DE15-05 – Design Exception – 2048 N. 12th Street (Fairmont Village)

DESIGN EXCEPTION #DE 15-05

RE: Access Location and Offsets – 2048 N. 12th Street (Fairmont Village)

**Re: Request for TEDS Exemption for Minimum Corner Clearance
Fairmont Village - 2048 North 12th Street**

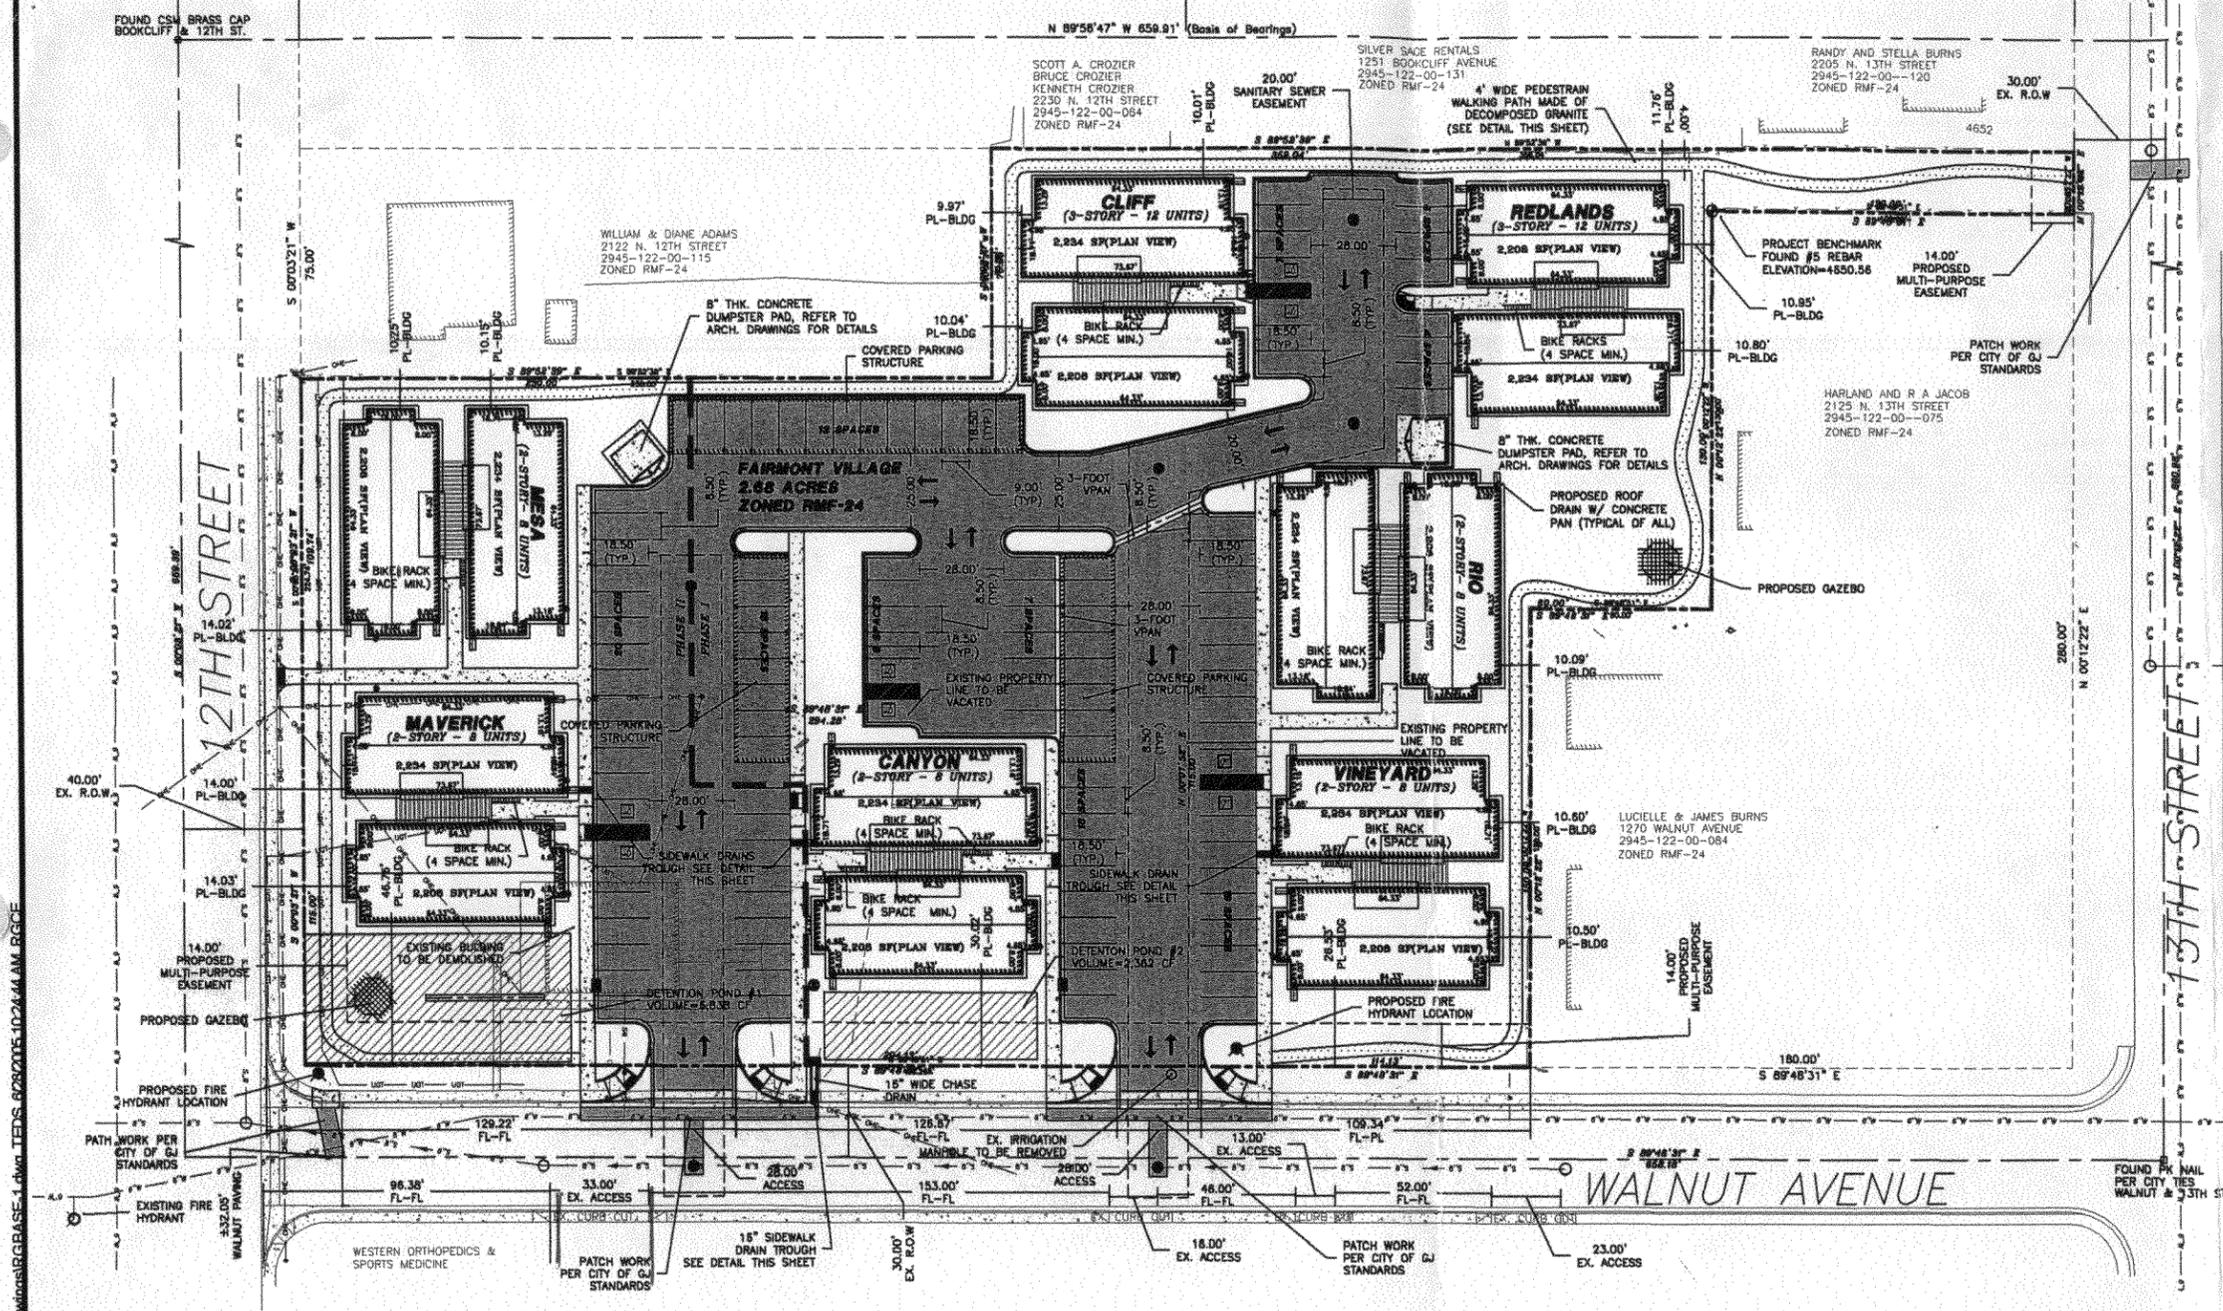
The final alternative is to construct the access 129-ft from the 12th Street flowline. This access location optimizes the site traffic flow patterns on the 2.68-acre site and allows the second access location to align with an existing residential driveway curb cut. If vehicles stacking at the intersection of 12th and Walnut cause a que that blocks the western access, the second access would still be visible by a driver wanting to access the apartment complex.

FAIRMONT VILLAGE
WALNUT STREET SPACING
2018 NORTH 12TH STREET
GRAND JUNCTION, COLORADO

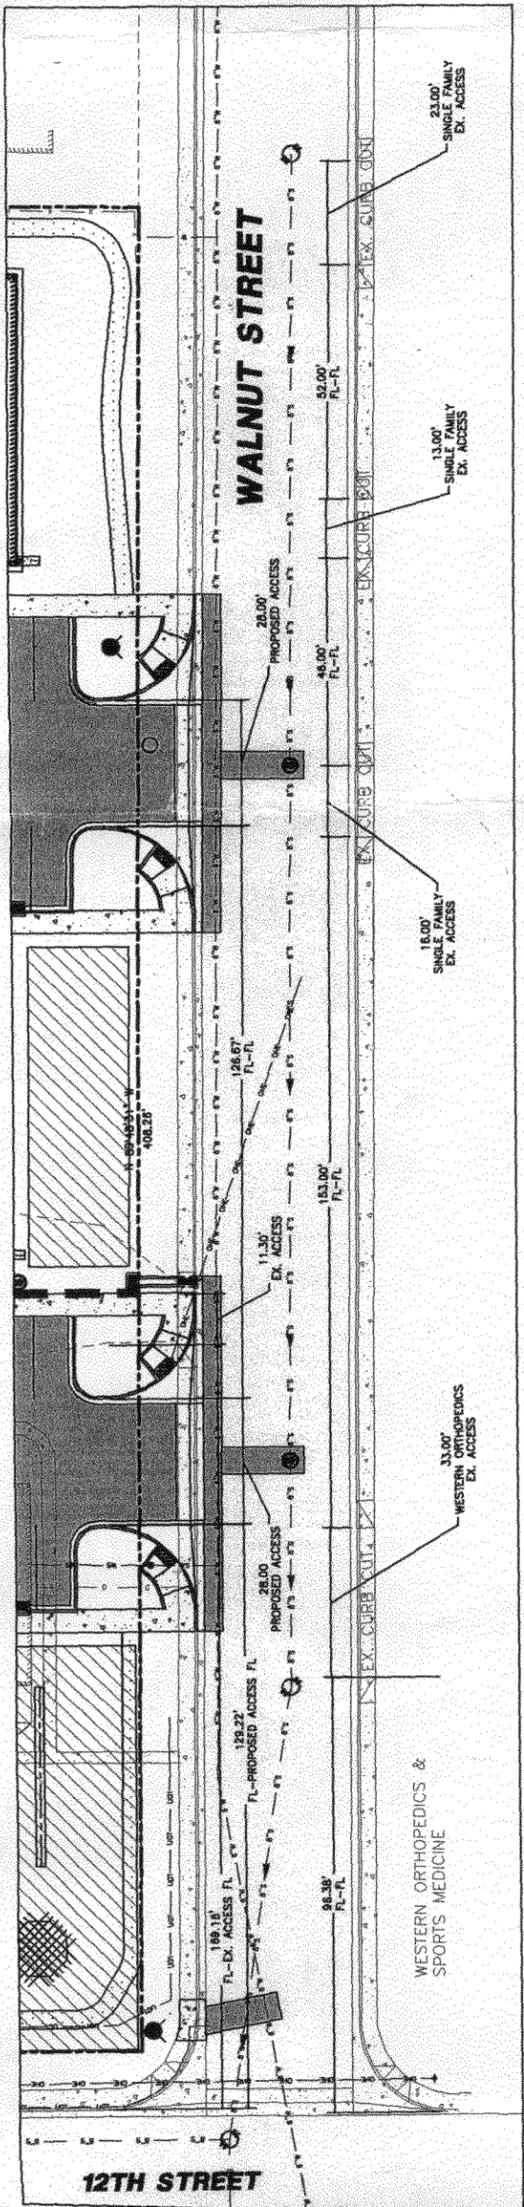
The TEDS Committee reviewed the subject TEDS Exception relating to allowance of a second, westernmost access which does not conform with TEDS for the following:

- a) Corner clearance from a signalized intersection TEDS 4.1.3 (150')
- b) Access offset is less than 50' per TEDS 4.12 "Offsets".

The TEDS Committee requested that the applicant demonstrate why the variance was necessary and show the Committee what one access might produce in terms of site layout. Staff further asked the applicant to clearly explain why one access would not work and what options were explored. Included in the TEDS Exception is the extent of the response.

While I do not believe that variance in this particular circumstance creates a safety issue or a traffic operations issue, there is clearly a way for the site to develop and address necessary vehicle circulation, TEDS access requirements, and fire department access standards.

The alternate site layout does not provide adequate parking per Z&DC and it has not been confirmed if the original or this alternate proposed site plan produces adequate open space per the Z&DC. In either configuration, some loss of number of housing units, and the resulting reduction in number of parking spaces may be required.

There are historic on-street parking issues in the neighborhood and adequate on-site parking is necessary. The alternate design allows for more on-street parking.

I recommend denial of the TEDS Exception.
